<b>Docket Number:</b>	21-AFC-02
<b>Project Title:</b>	Willow Rock Energy Storage Center
<b>TN #:</b>	259220
<b>Document Title:</b>	Willow Rock Data Request Set 2 Response
<b>Description:</b>	N/A
<b>Filer:</b>	Kathryn Stevens
<b>Organization:</b>	WSP USA Inc.
<b>Submitter Role:</b>	Applicant Consultant
<b>Submission Date:</b>	9/19/2024 11:11:49 AM
<b>Docketed Date:</b>	9/19/2024

**Willow Rock Energy Storage Center (21-AFC-02)**  
*Data Request Response Set 2*

### LEGEND

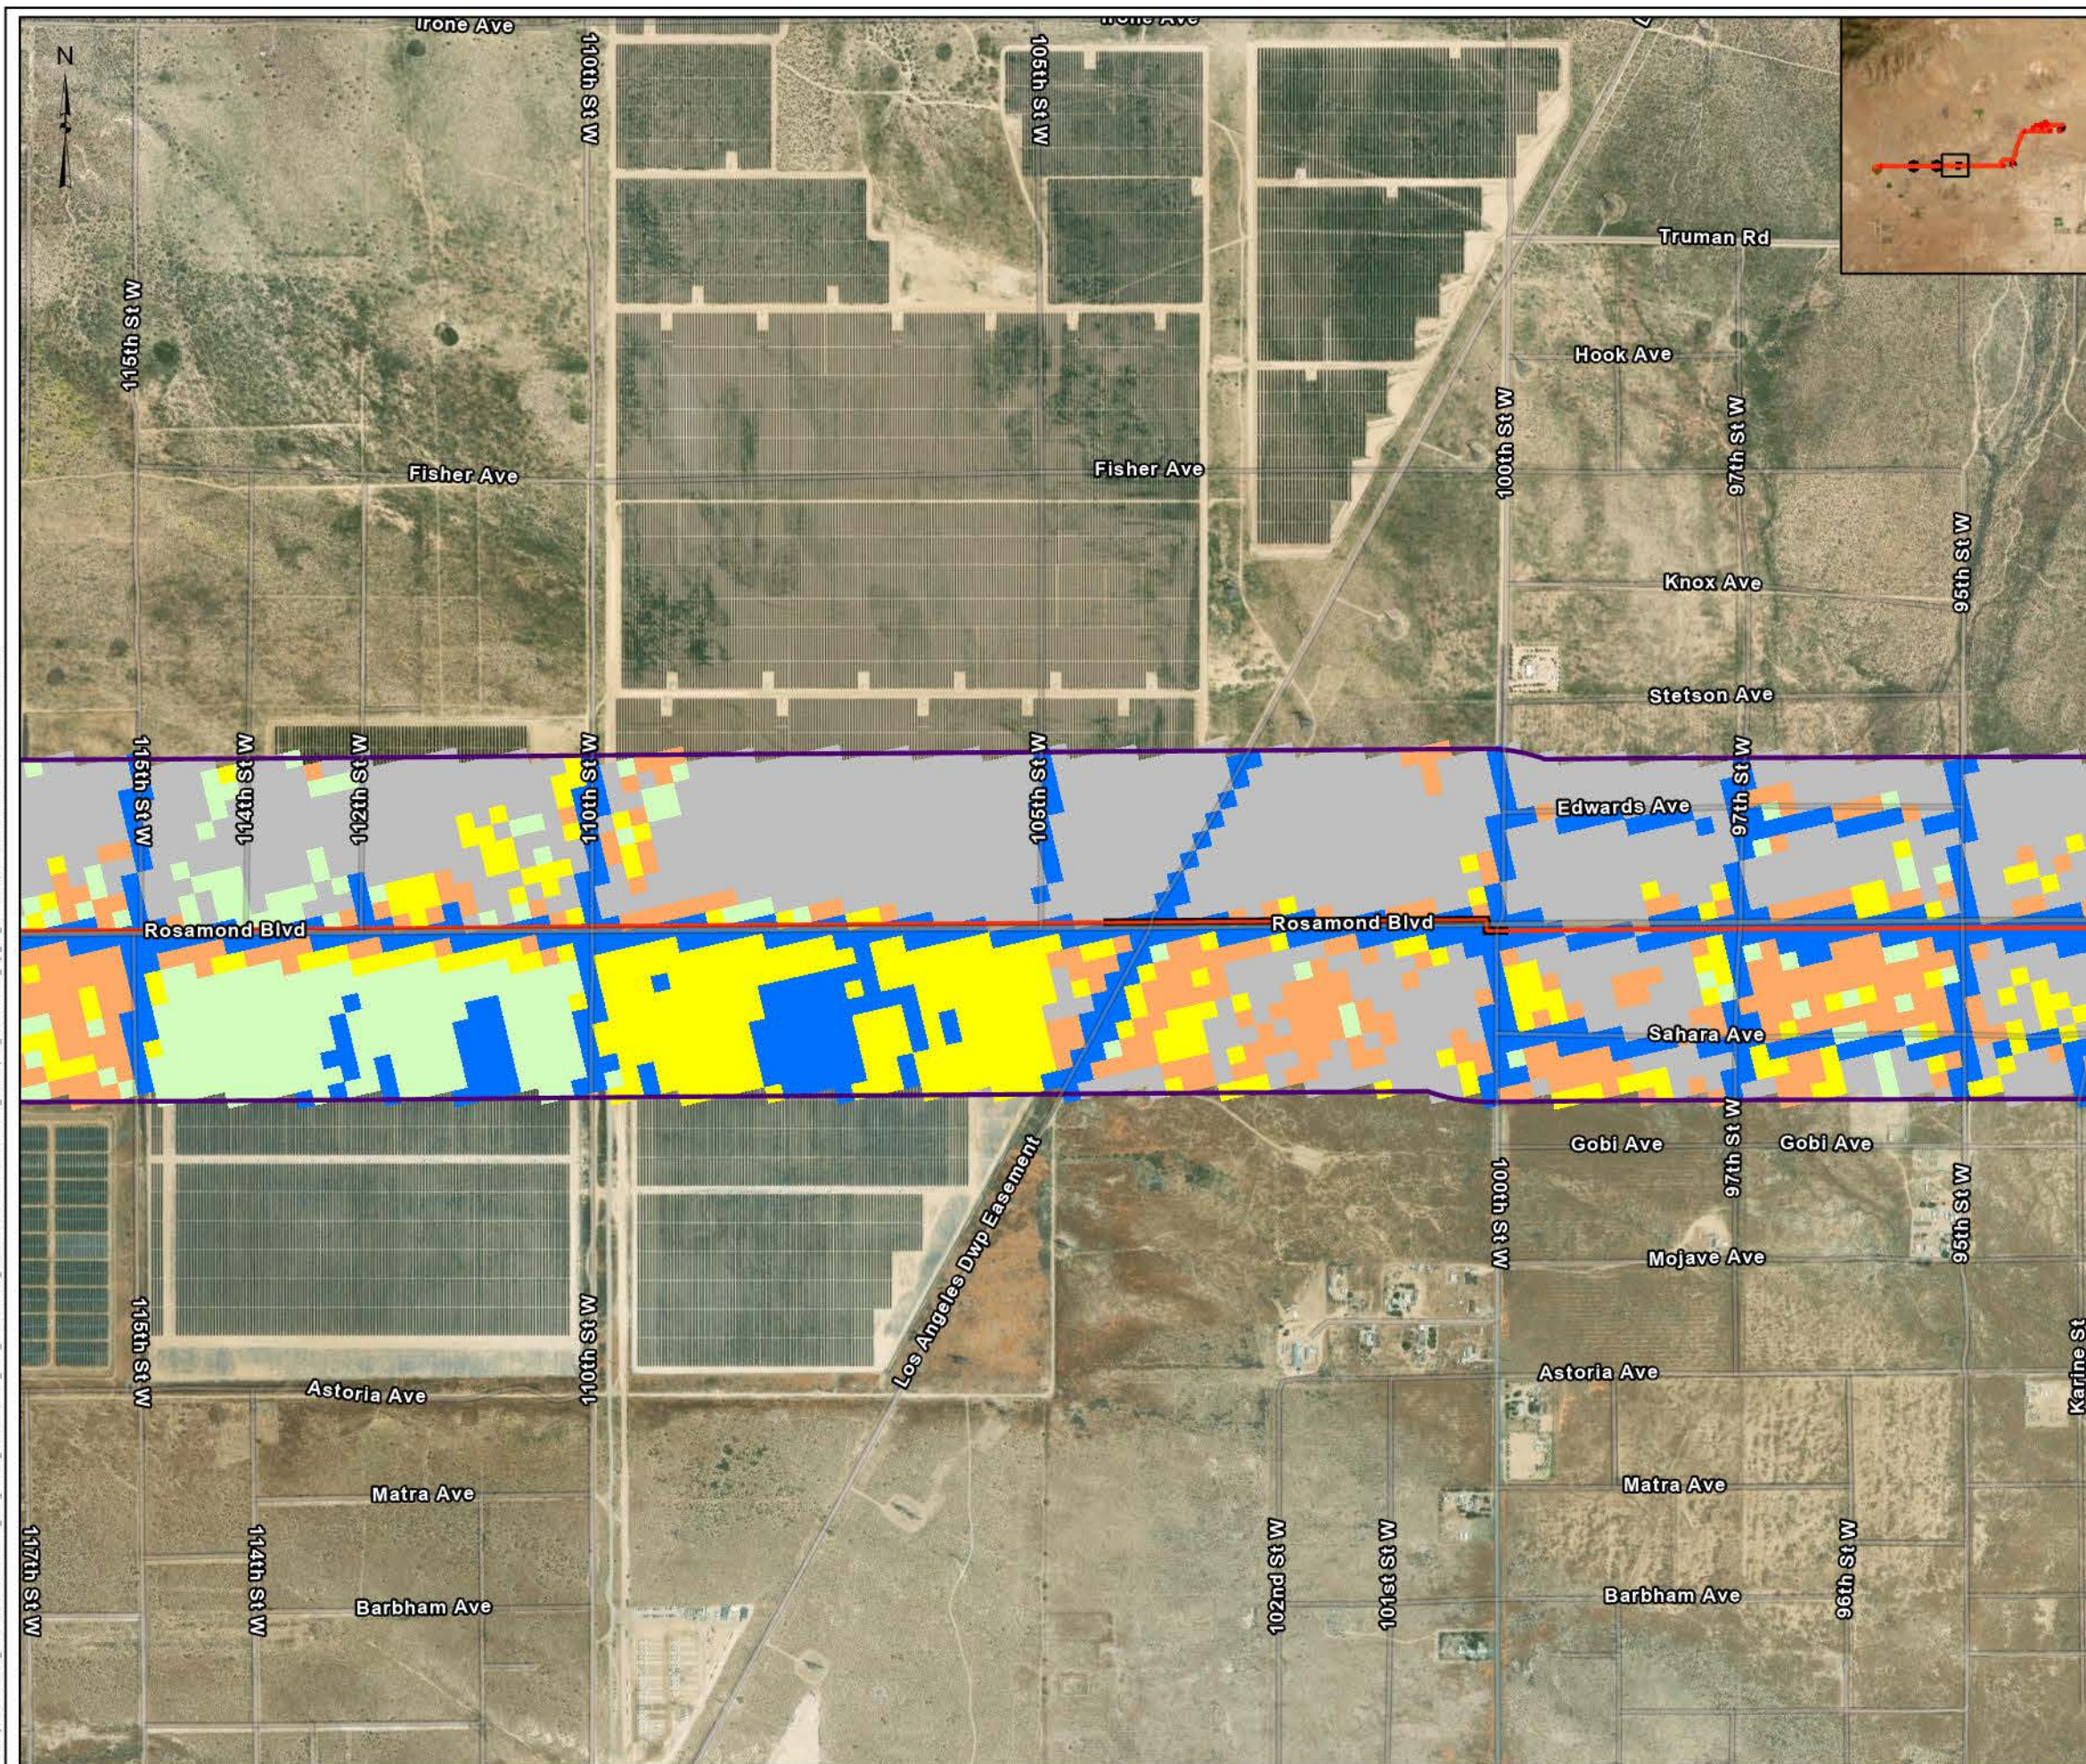
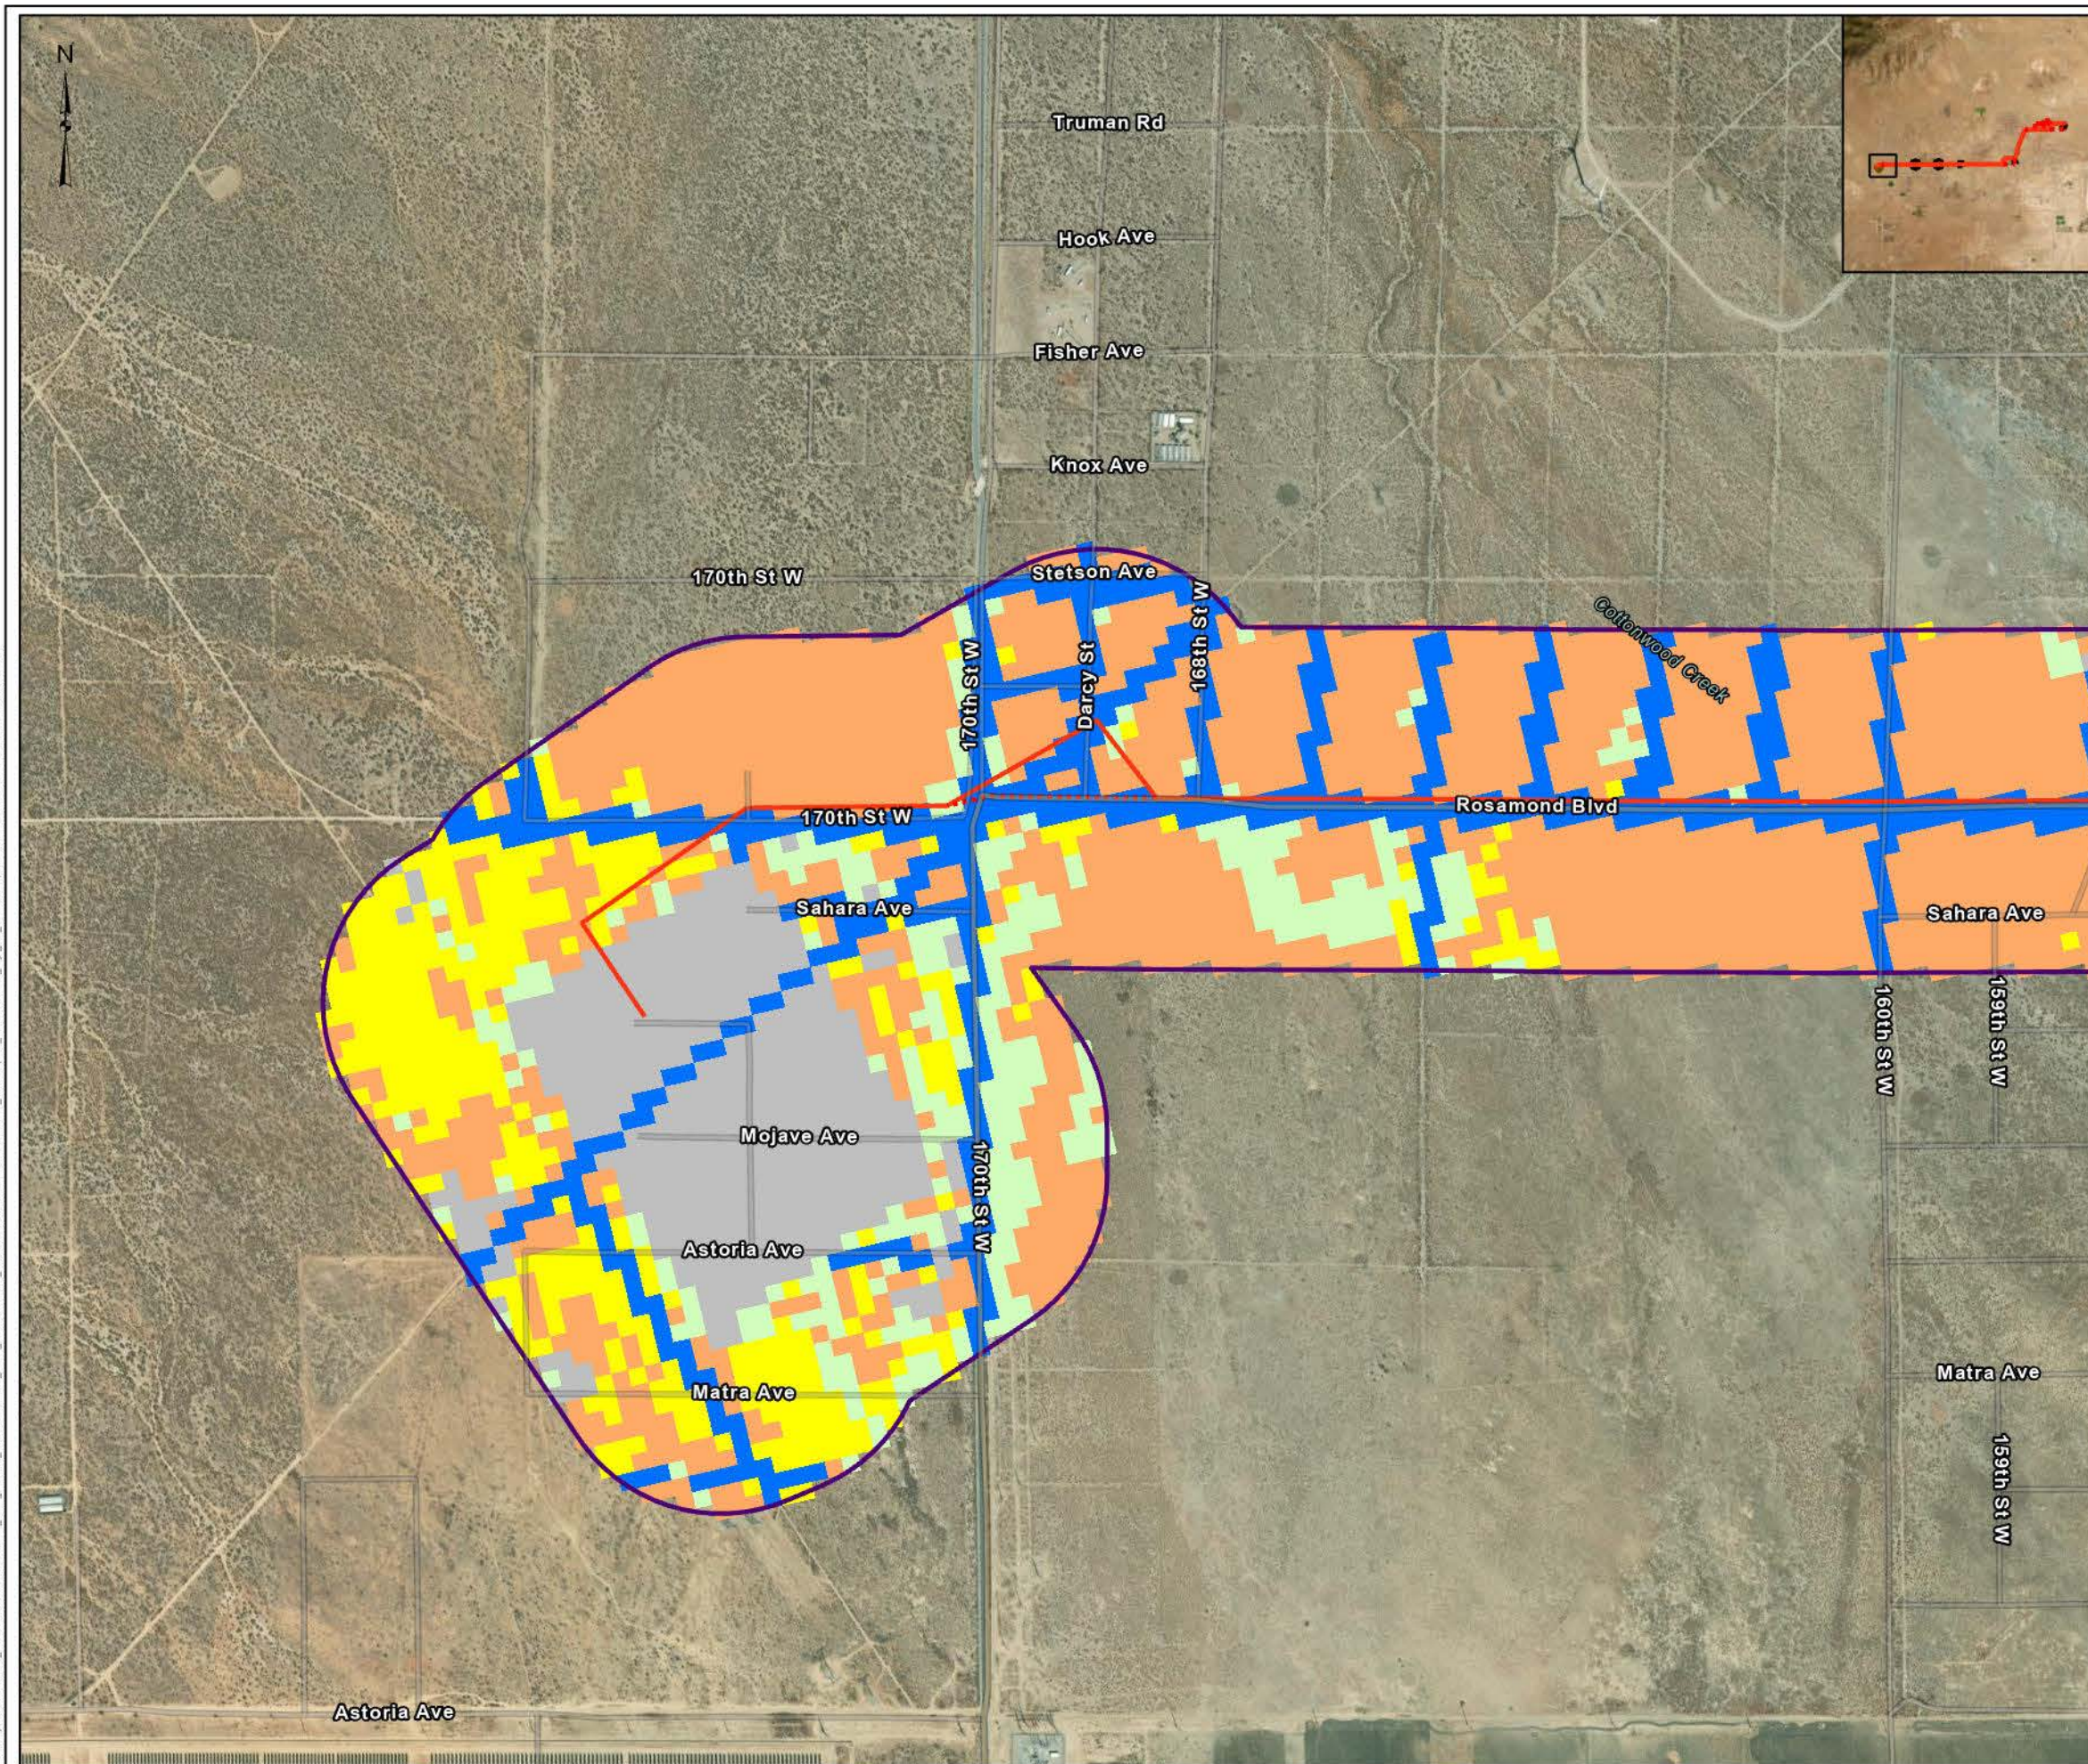
**DR36:** *Provide a discussion and map that indicates how each identified Fuel Model relates to the Project specifically and where they are in relation to each component of the Project, including the transmission line.*

**Response:** Attachment DR36-1 provides a map showing the relevant fuel models in relationship to project components. The following describes how each fuel model geographically relates to the Project:

- Based on data from LANDFIRE, the fire behavior fuel models (FBFM) surrounding the transmission line and Project components are FBFM2, FBFM5, and FBFM8.
- FBFM2 dominates the area on the eastern side of the WRESC site
- FBFM5 and FBFM8 make up the areas to the west of the WRESC site along Dawn Road.
- FBFM2 dominates the area surrounding Mojave Tropic Road.
- The majority of Rosamond Boulevard is surrounded by urban areas that do not include an FBFM, however FBFM2, FBFM5, and FBFM8 are dispersed along some sections of the road, with FBFM5 being the most dominant.
- The Whirlwind Substation is mostly surrounded by FBFM2, however, both FBFM5 and FBFM8 occur on the northeast side of the substation.

## Map of 10-in-a-Million Risk

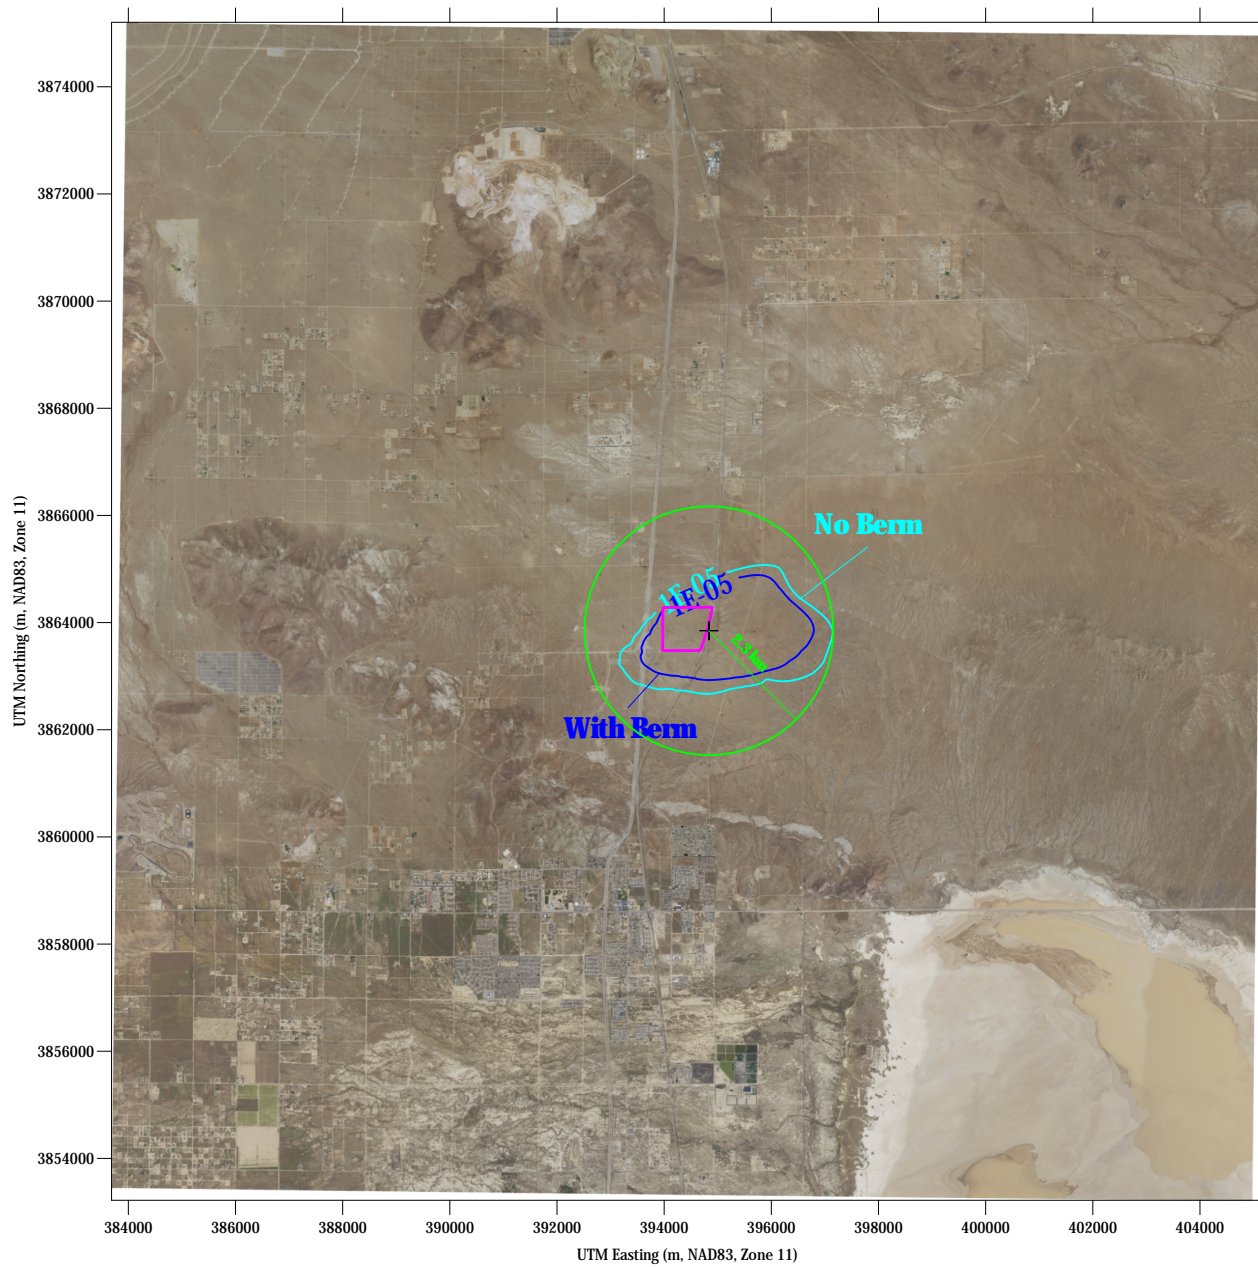
**DR39:** *Since the cancer risks at PMI are significant, please discuss how the applicant intends to use mitigation measures to reduce the cancer risk to a level of less than significant during construction and ensure the protection of public health. If the results of any health risk assessment results in a health risk of greater than 10 in one million, please provide a map containing health risk isopleths, including an isopleth showing the risk value of 10 in one million.*

**Response:** A map of the 10-in-a-million risk is provided with this response as **Attachment DR39-1** for both the berm and no berm options. The extent of the maximum 10-in-a-million risk (no berm option) is approximately 2.3 kilometers from the facility fence line boundary. As referenced in the application, there are no residential or worker receptors within this 2.3 km radius. Additionally, there are no structures or buildings located within this area, therefore, it is not expected that any member of the public would be exposed to this level of risk since there will be no public member residing or present in this very limited area with continuous exposure over the five (5) year construction period. Accordingly, public health risk associated with construction is expected to be less than significant and no additional mitigation is necessary.
